REQUEST FOR TENDER No. 20-062

Meadowood Community Centre Construction

**Addendum 4 (17 pages)
Issued: December 3, 2020**

ADDENDUM – 04

HORIZ. SCALE:	AS SHOWN	DRAWING NO.:	C01
VERT. SCALE:	AS SHOWN	PROJ. NO.:	20-539
SHEET 1 OF 1		VERSION NO.:	1

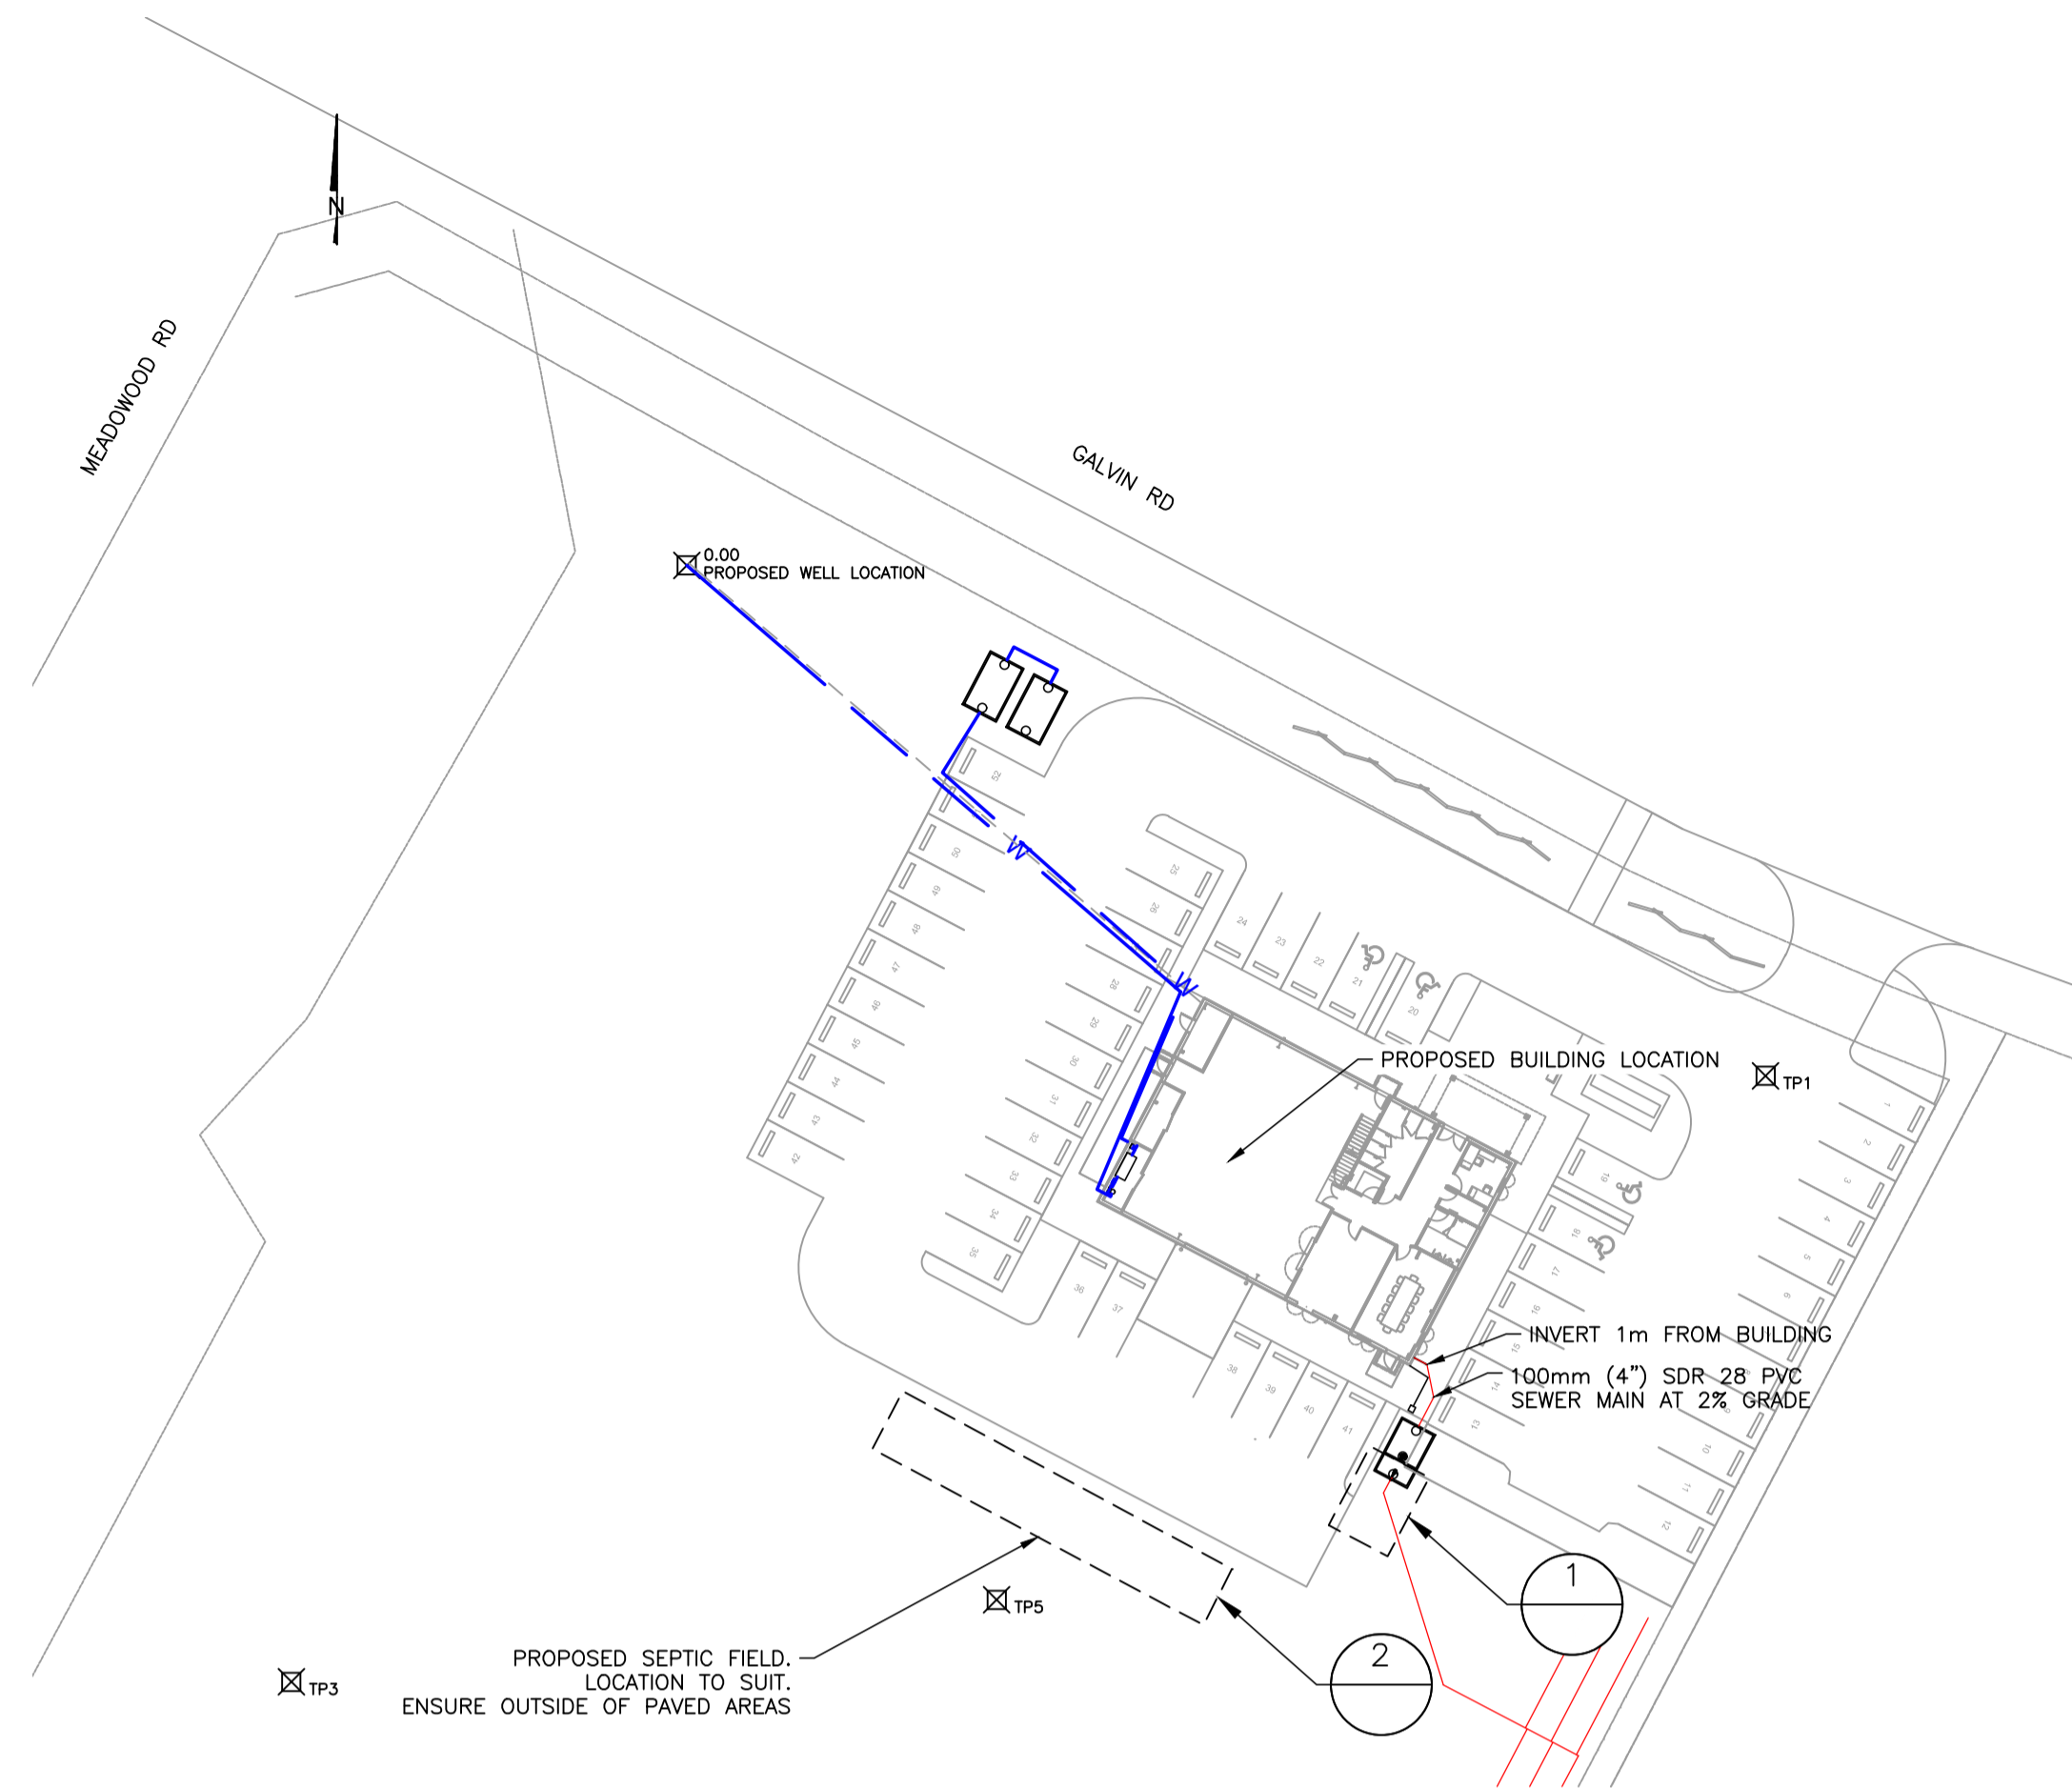
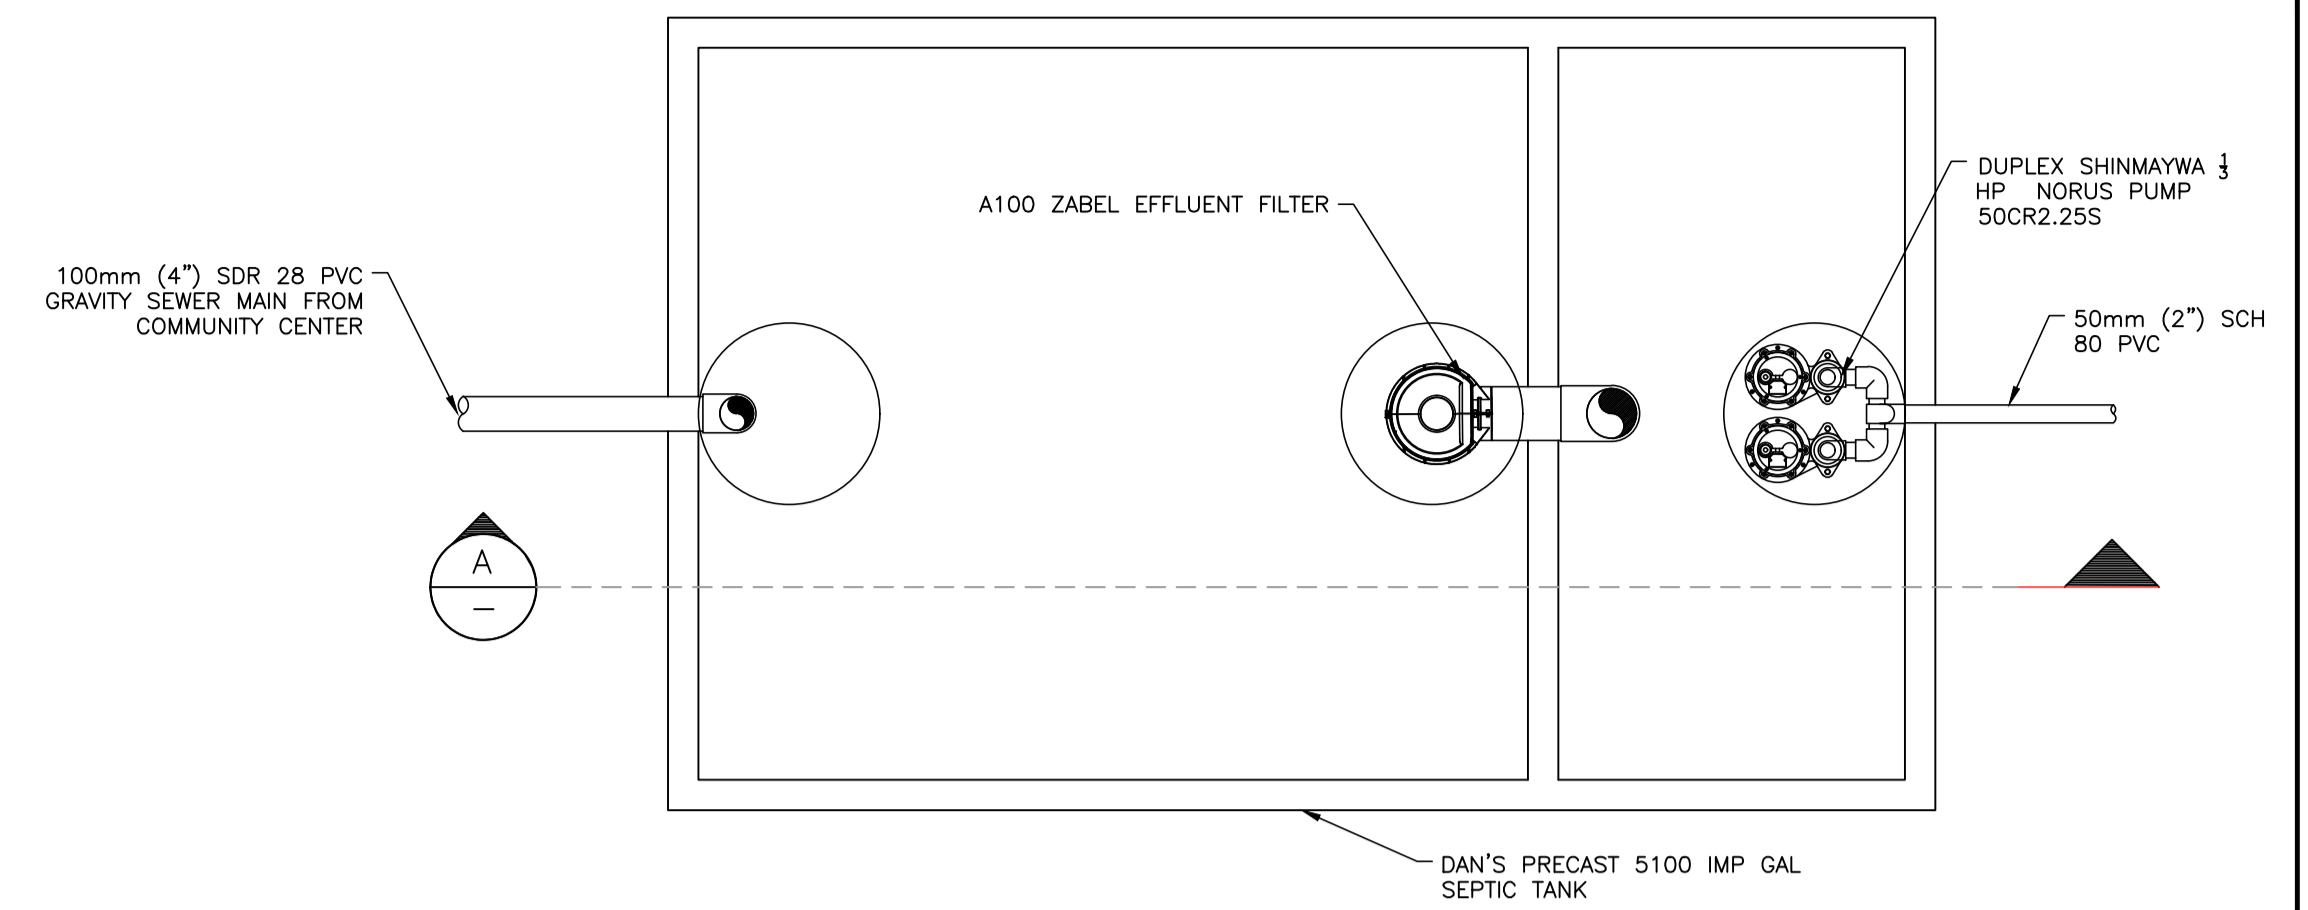
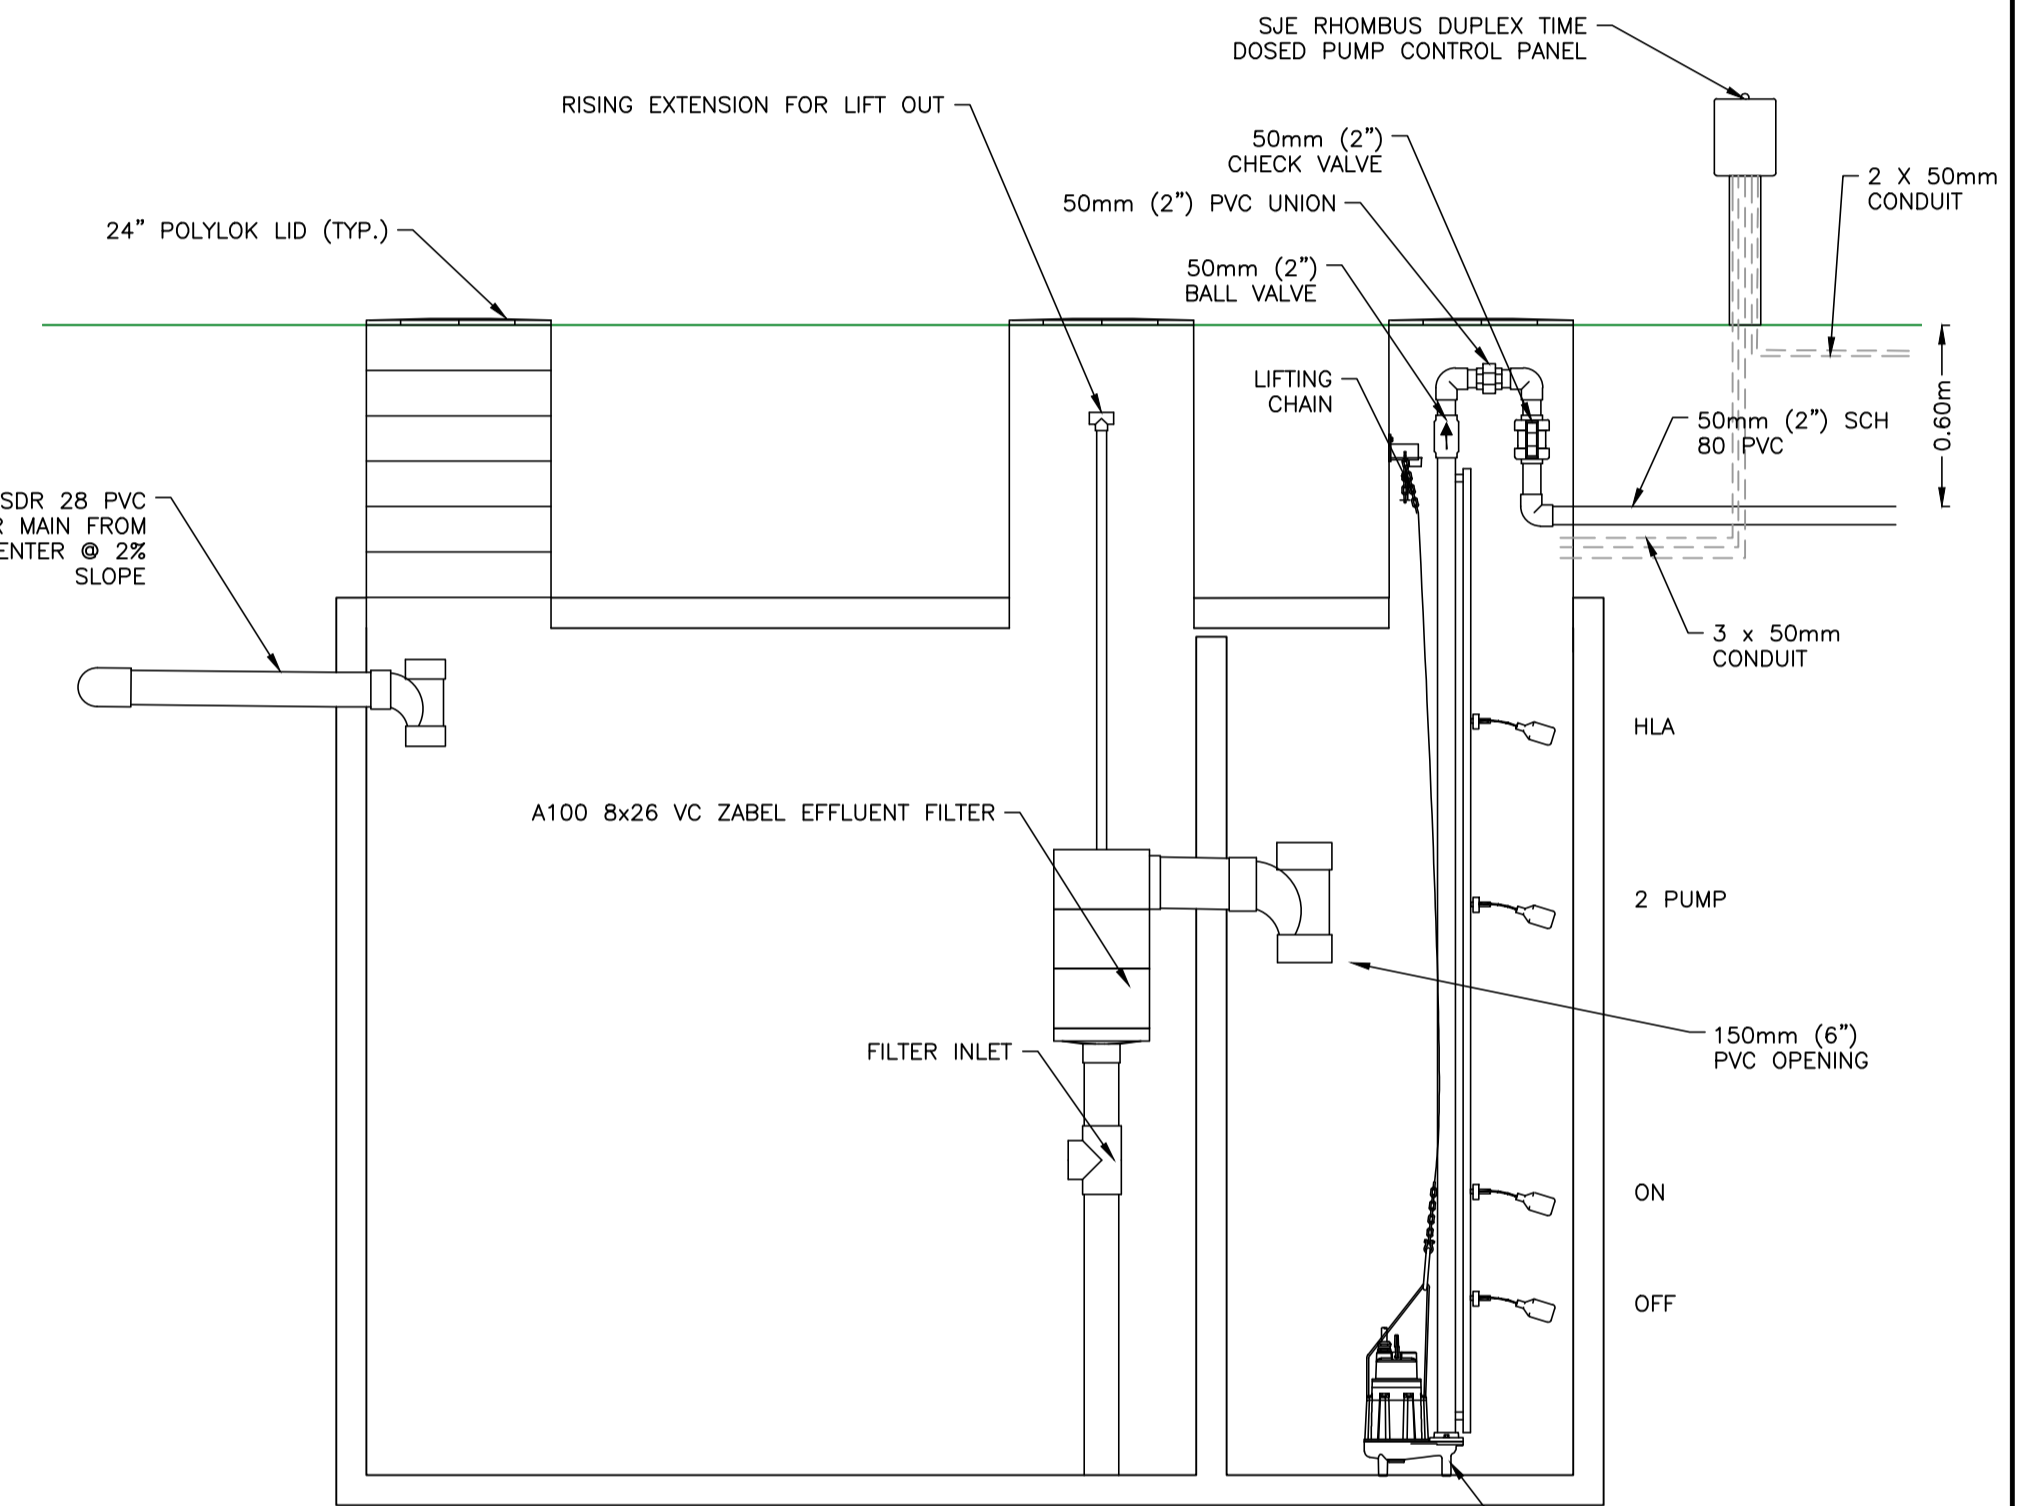
NO.	DATE	BY	REVISIONS	ENG
	2020.11.30	C.S.	CHANGED FITTINGS AND ADDED FLOAT TREE	M.S.
(1)	2020.12.01	C.S.	ADDED PIPE THICKNESSES	M.S.
